Technical Review of Regulatory Proposals

Review of Proposed Network Augmentation and Replacement Capital Expenditure in Energex's Regulatory Proposal 2015 - 2020

Australian Energy Regulator

APRIL 2015

Figure 12: Capex risk/spend optimisation process

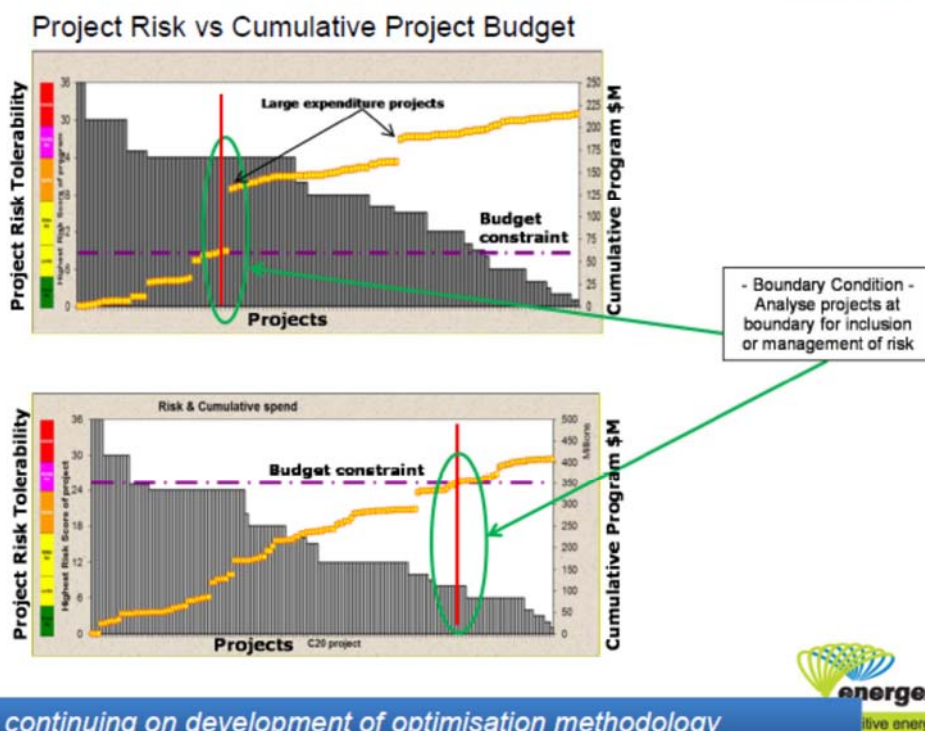
69. We observed that Energex's defined budget/risk boundary condition appears to result in the acceptance of a disproportionate number of low risk category projects. We reached this view following Energex's response to our questions during the on-site sessions. As discussed in section 5, we did not find sufficient evidence that the budget/risk boundary condition for the RP was tested beyond defining a desired price outcome.²⁶
70. In response to a more effective top-down challenge, we consider that the approval of lower risk and lower cost/benefit projects might have been rationalised or deferred. In the absence of clear evidence of such a challenge, we are unable to conclude that the proposed expenditure is prudent and efficient.

Figure 13: Energex's perception that declining PoW may impact ROI

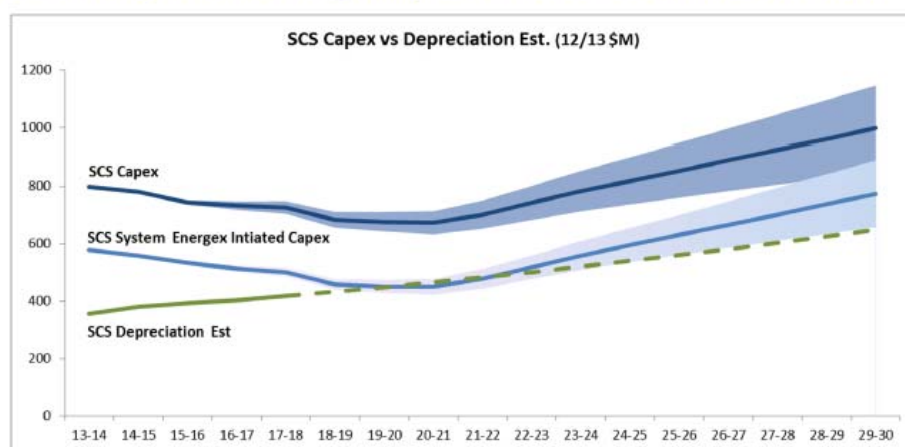
72. We note Management's advice that "refurbishment capex represents a practical lowest prudent Capex". However, we do not consider the advice (as shown in Figure 13 below) that "further work is required to determine the impact of declining capital expenditure relative to Energex depreciation and its impact on investment returns"²⁹ to be an effective objective for the budget/risk boundary.

Figure 17: Comparison of augmentation program with AER augex model

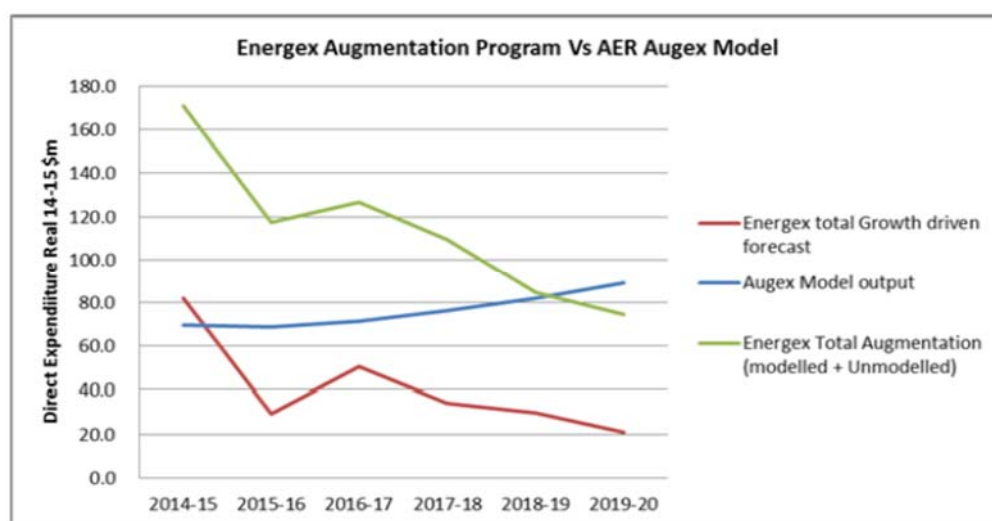
115. Energex has compared its augex forecast with outputs from the AER's augex model (as shown in Figure 17 below) and concluded that this "*shows Energex in a favourable position with modelled output higher than bottom-up build.*"

Figure 18: Program risk for augmentation capex

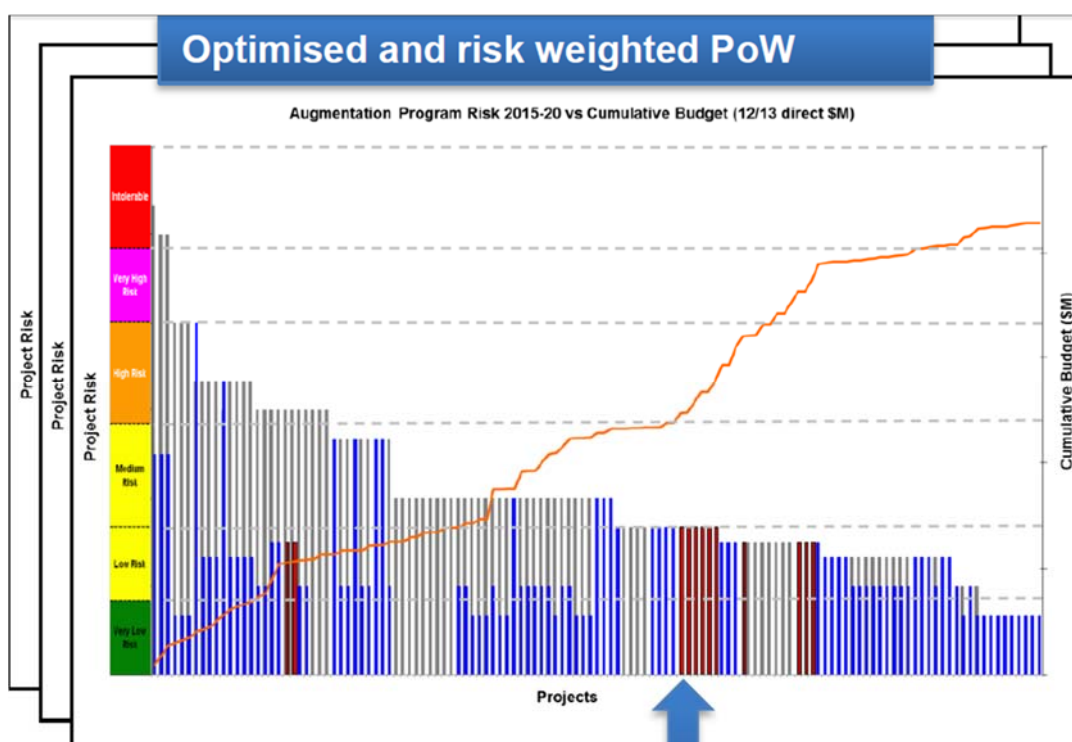
122. We note that Energex's program of work risk scores for augmentation projects as shown in Figure 18 contain a large number of projects with low risk ratings. From the graph, it would appear that these comprise around 50% of the proposed augex. This suggests that, despite the significant decrease in proposed augex relative to the current RCP, there may be a significant component of augex that could be further deferred. We consider this further in our project-level assessments in section 6.

Figure 19: Comparison of replacement program with repex model

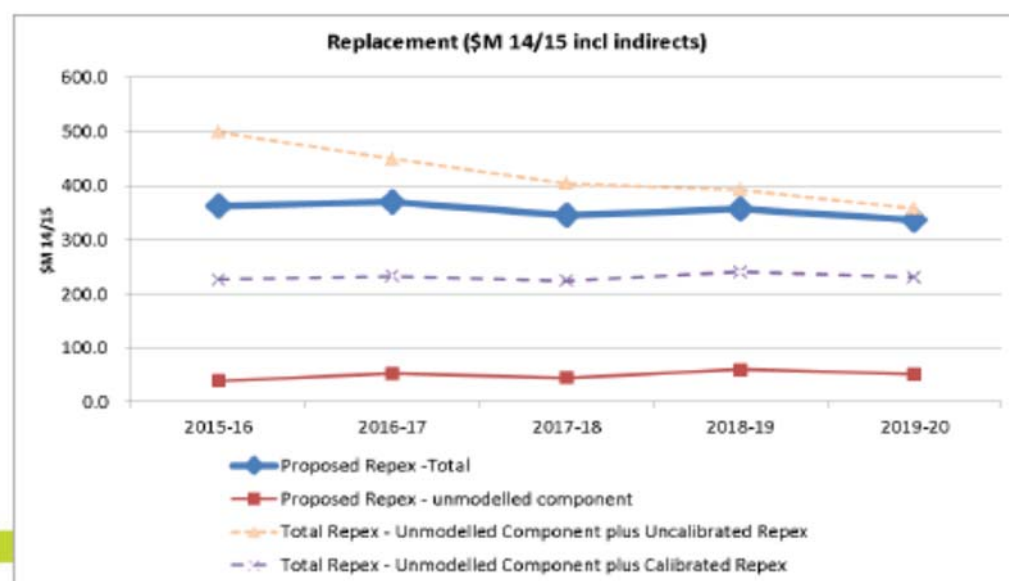
132. Whilst it is not within our scope to consider the validity of the repex model output that Energex has provided, it is difficult to see how these outputs provide any meaningful top-down bearing on the proposed expenditure level given their wide range.

Figure 20: Program risk for replacement capex

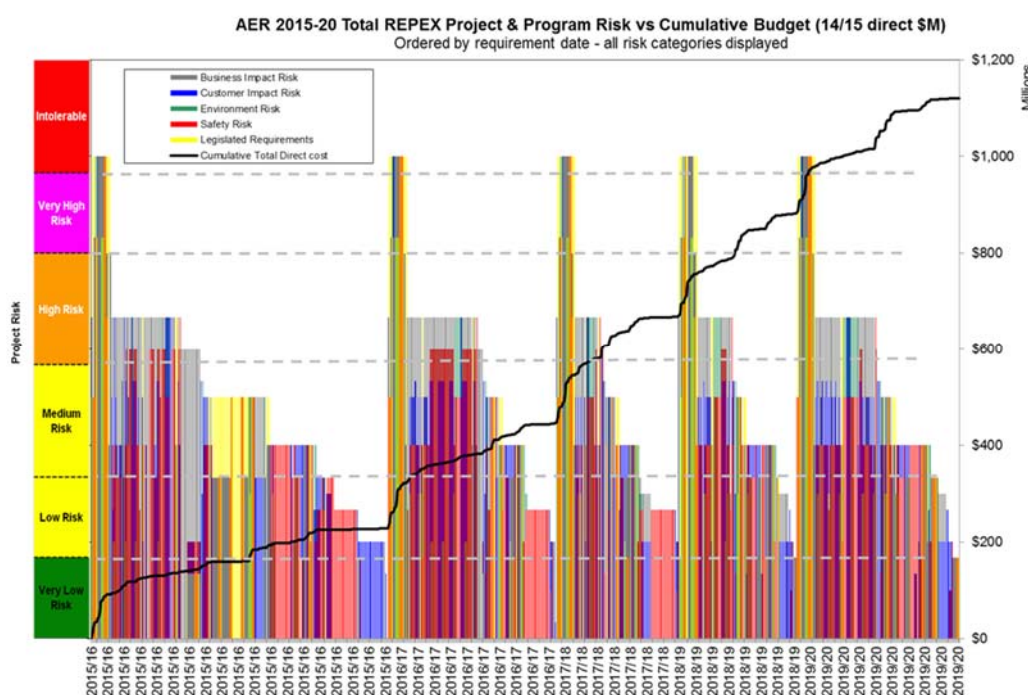
138. Finally, we observe that the risk profile of projects over time does not seem to provide strong evidence of risk-based prioritisation. We observe 'Intolerable' risks being more-or-less evenly addressed over the period and a significant number of medium and low

Figure 25: Sensitivity of augmentation costs to forecast demand

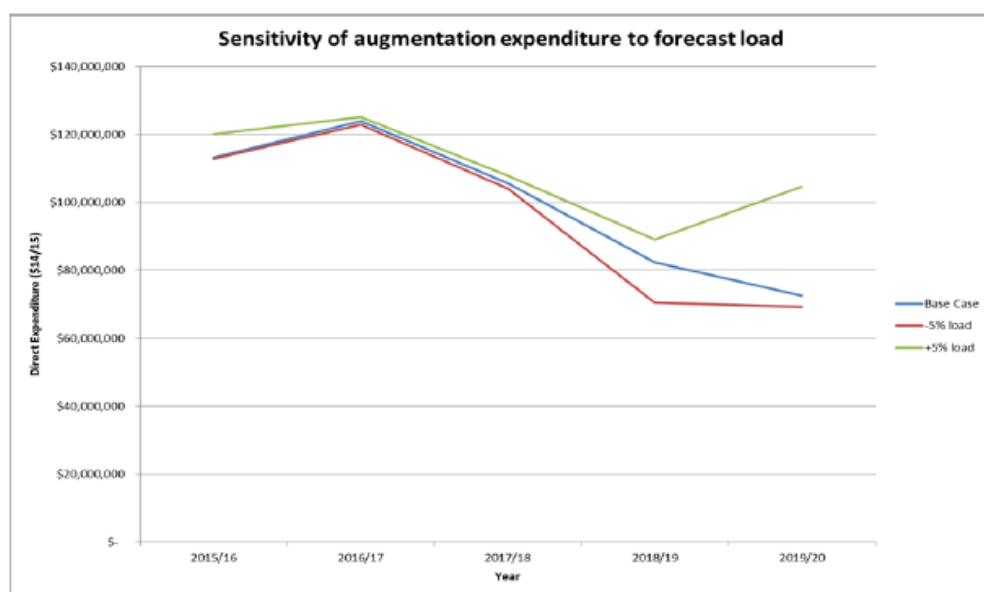
176. We sought further information on the sensitivity of the proposed augex to the demand forecast. Energex advised that *"the augmentation forecast expenditure will not materially change with a change in demand forecast"*.⁶⁸ Figure 25 below illustrates the sensitivity of Energex's augex to a +/-5% variance in load. The chart suggests that no material change in augex would arise until 2018/19.

Figure 27: Energex sub-transmission augex – annual % vs RCP total

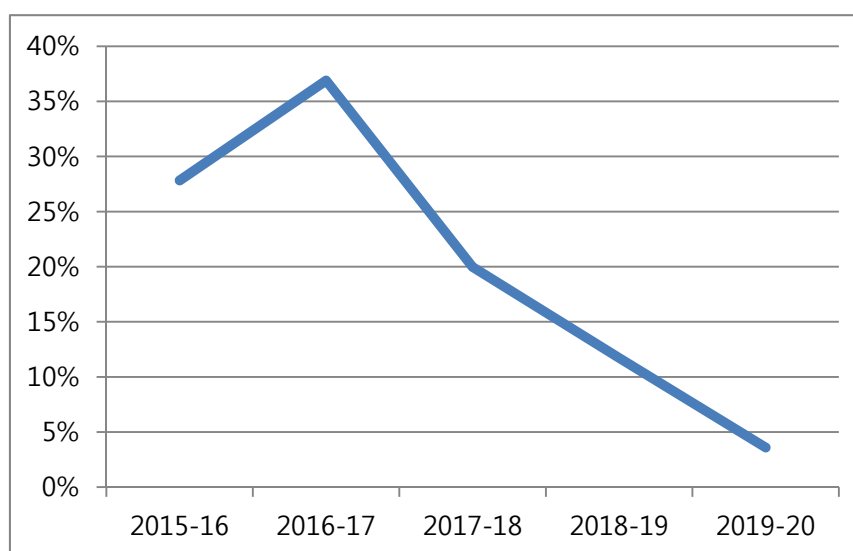
193. The sub-transmission augex is heavily front-loaded with 85% occurring in the first three years of the RCP. This is unlikely to be a realistic forecast of what will actually occur and it seems more likely to us that some work will be deferred and smoothing of the profile is likely. Whilst the deferral and smoothing may not materially alter the overall augex for the RCP, it will increase the probability that some work later in the program will be deferred to the 2020/25 RCP. Energex has not provided evidence of consideration of such possibility.
